# Index 102-615 Multilane, Work in Intersection

#### **COMMENTARY**

### **COMMENTS AND RESPONSES**

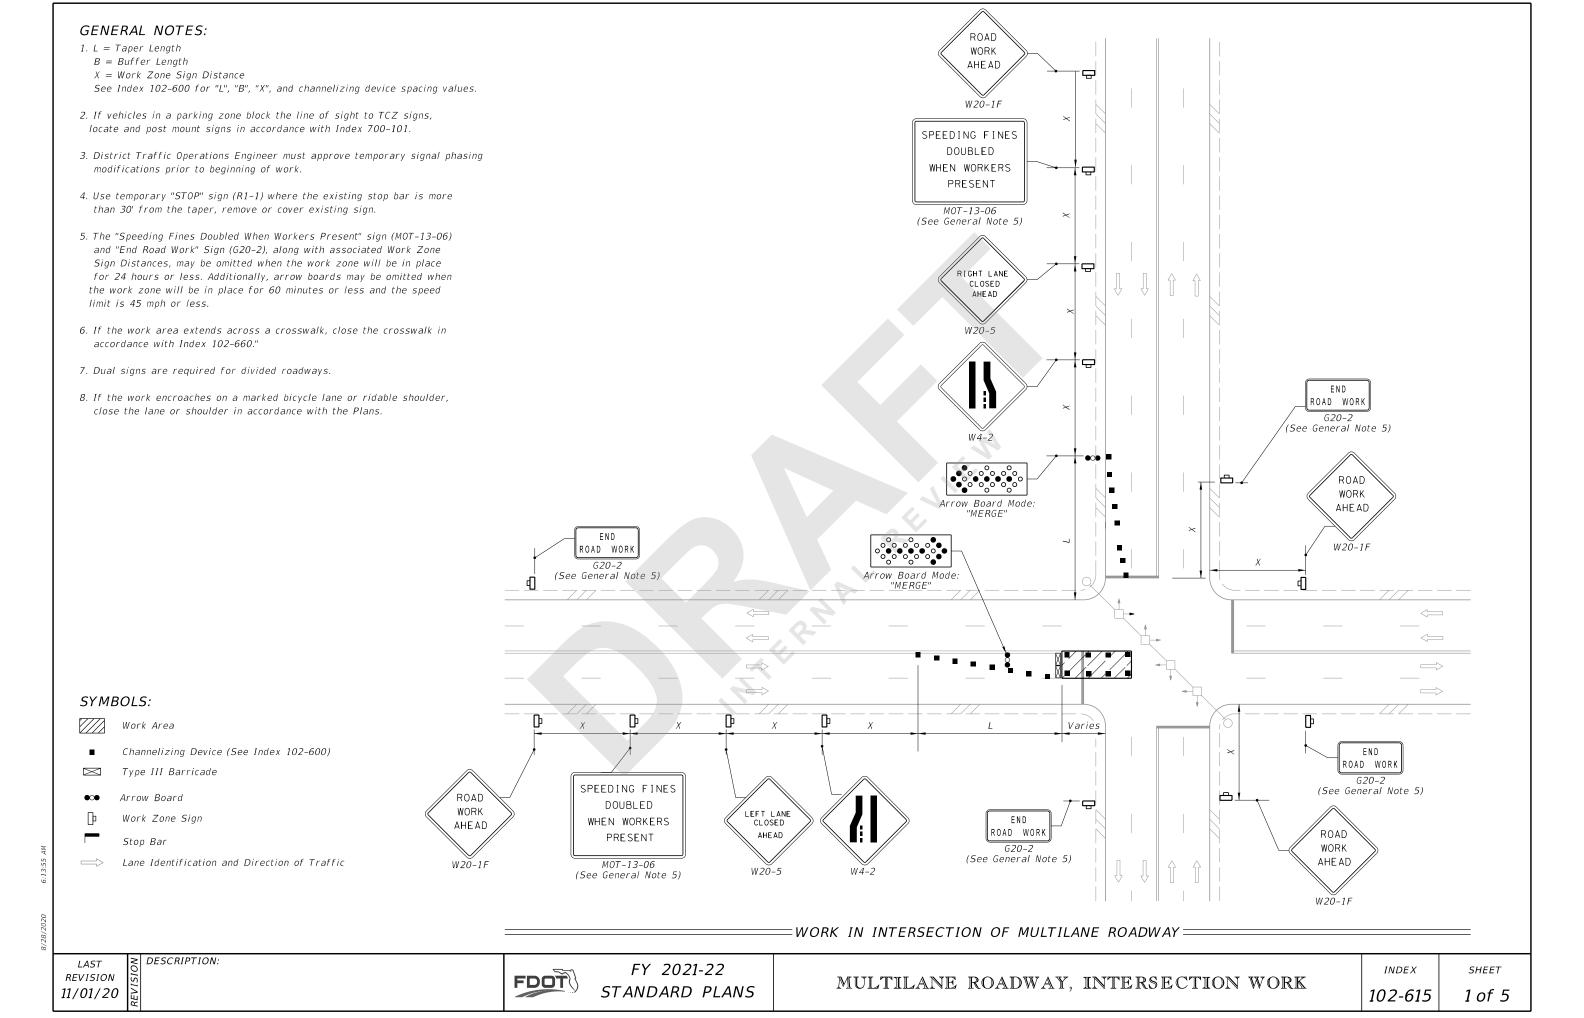
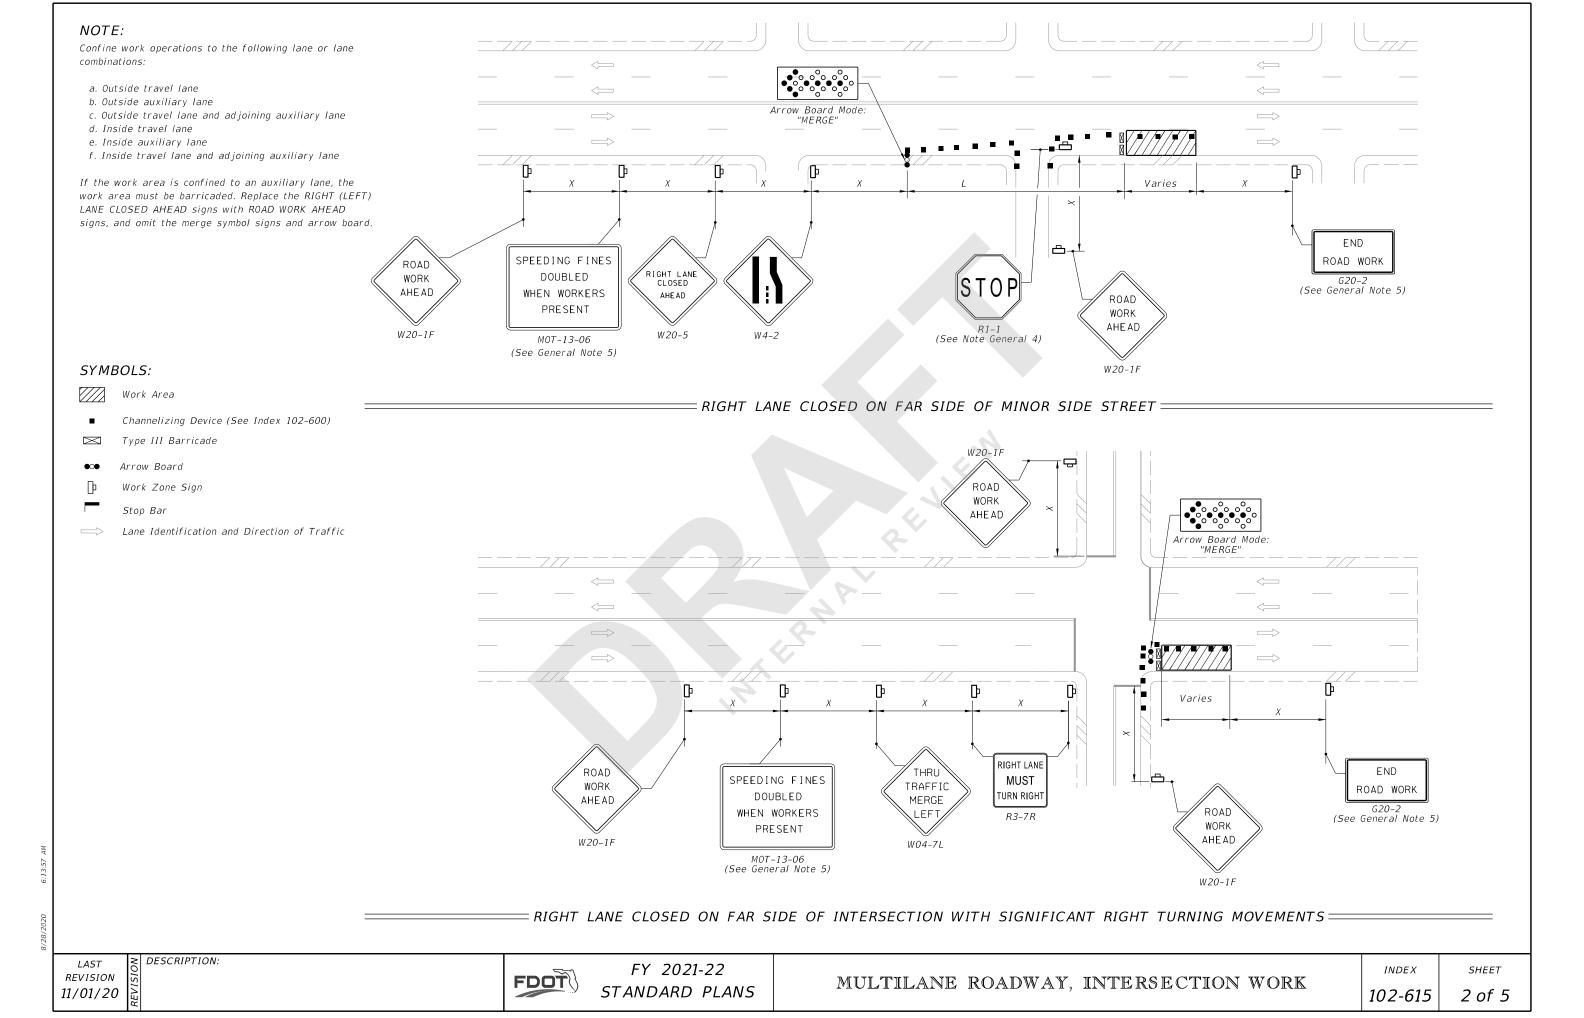
1. Sheets 2 & 3 Notes: In addition to omitting merge symbol sign for auxiliary lane work only, should omit arrow board to prevent confusion for need to merge. May be encompassed within "omit the merge symbol signs" statement but not clear

**RESPONSE:** Agreed

**Change Made:** Clarified notes to include omitting the Arrow Board.

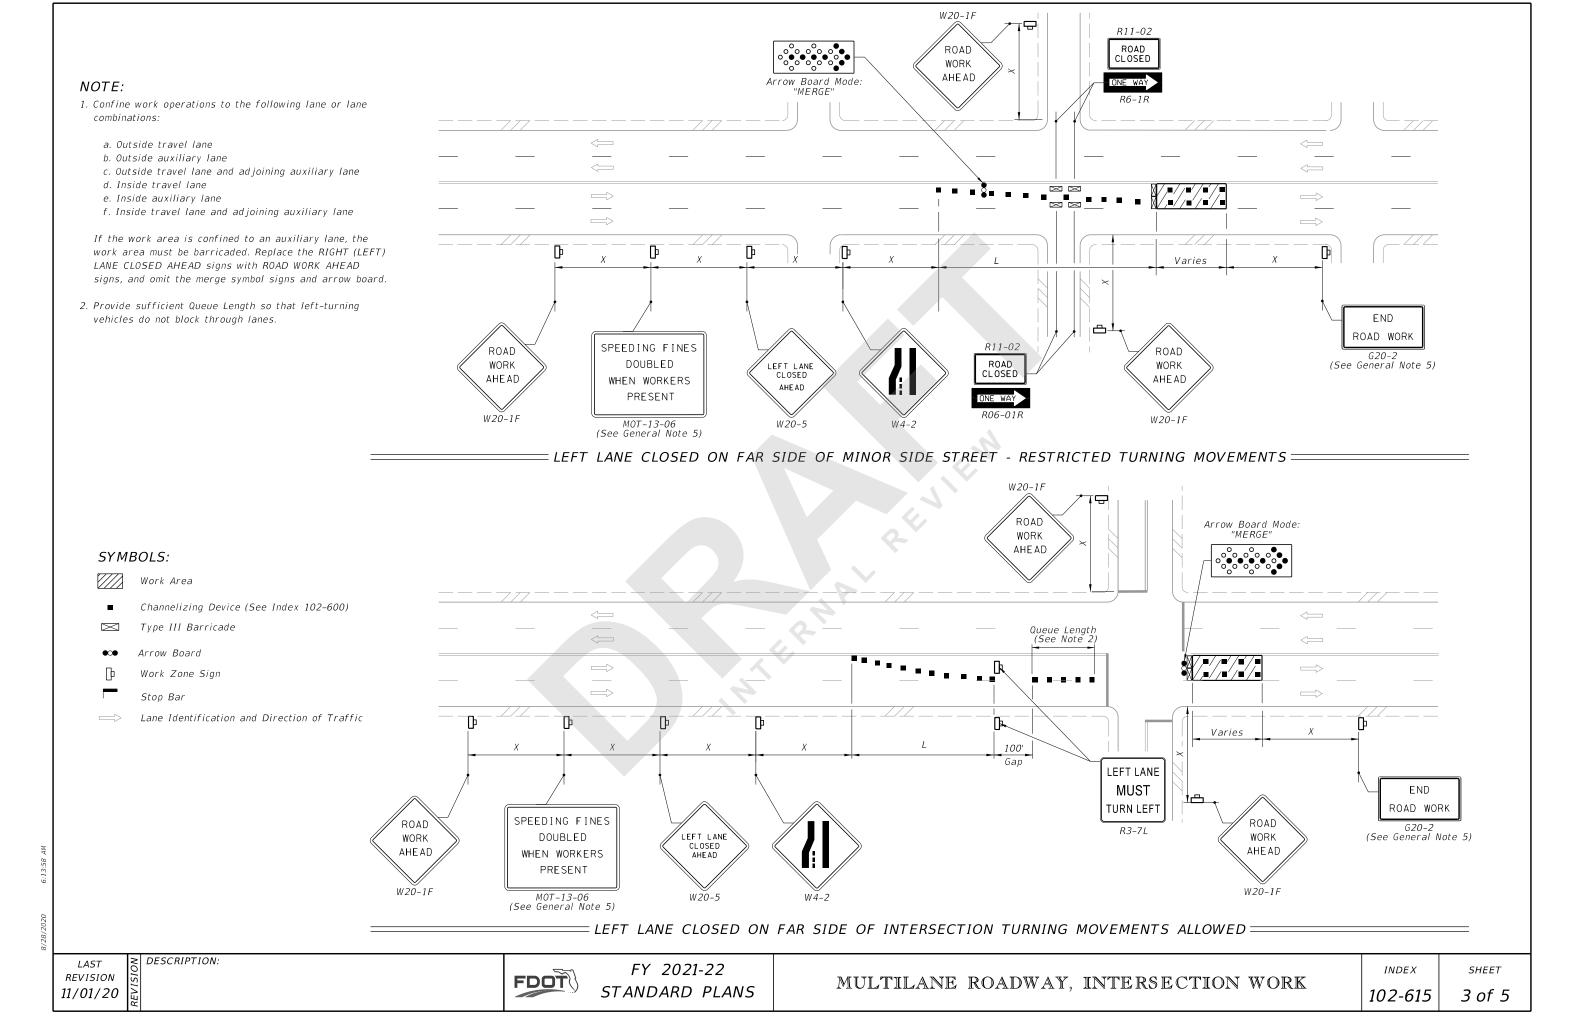
2. Sheet 5, Bottom Figure: "L" distance  $(S^2/5)$  fraction not legible unless zoomed in significantly. Consider alternative text or equation size

**RESPONSE**: Agreed

**Change Made:** Changed text to make legible.
